Stormwater Detention and Infiltration Design Data Sheet

Stormwater Facility Name: POND B

Facility Location & Jurisdiction: 4-WAY COMMERCIAL, EL PASO COUNTY, COLORADO

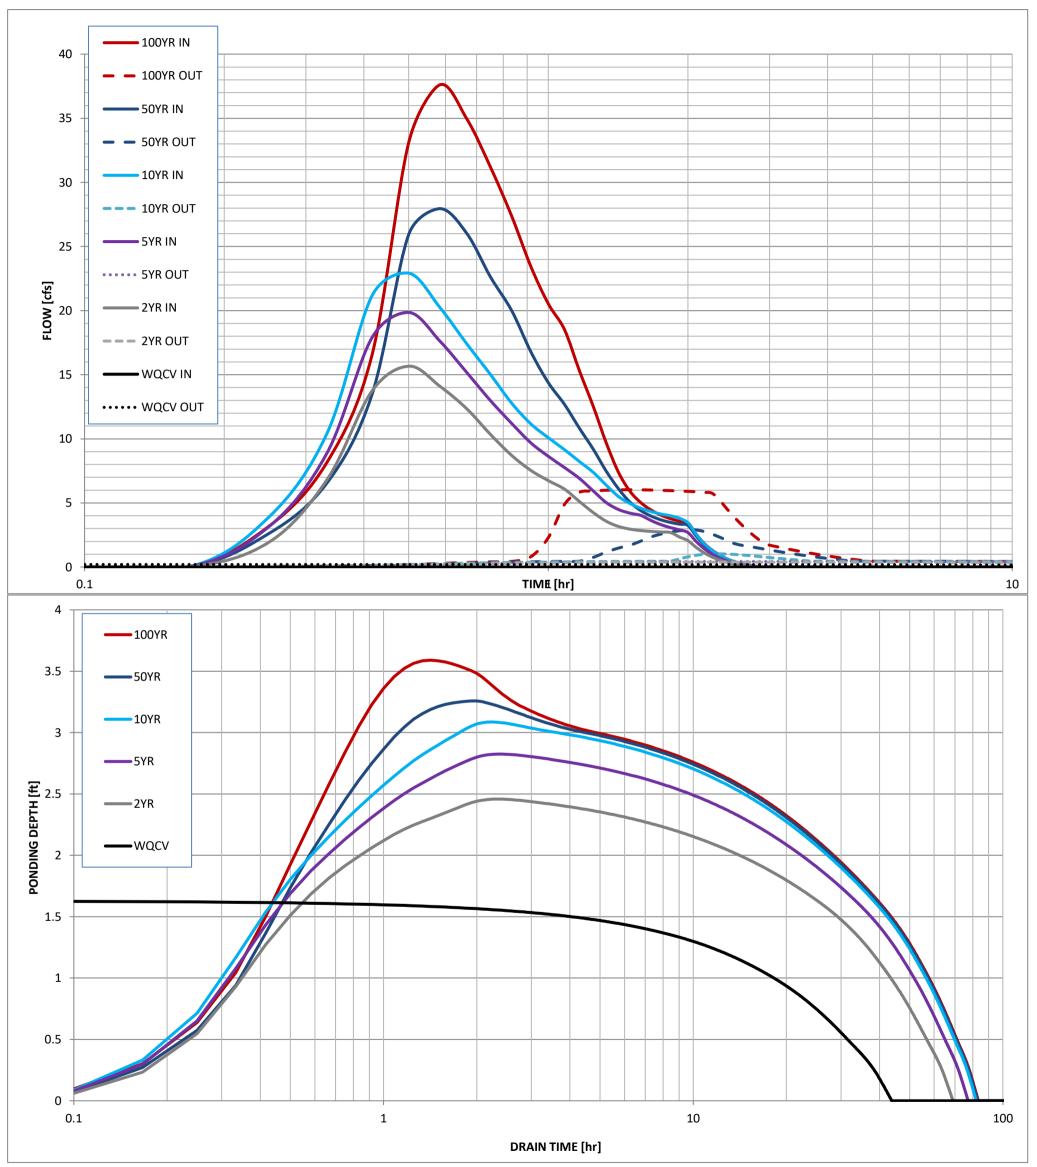
Why are the following pond calcs provided when no detail drawings were provided to compare the calcs to? If the pond design is to come under a different EDARP submittal (like an SF, for example) than just remove the calcs from this drainage report to avoid confusion.
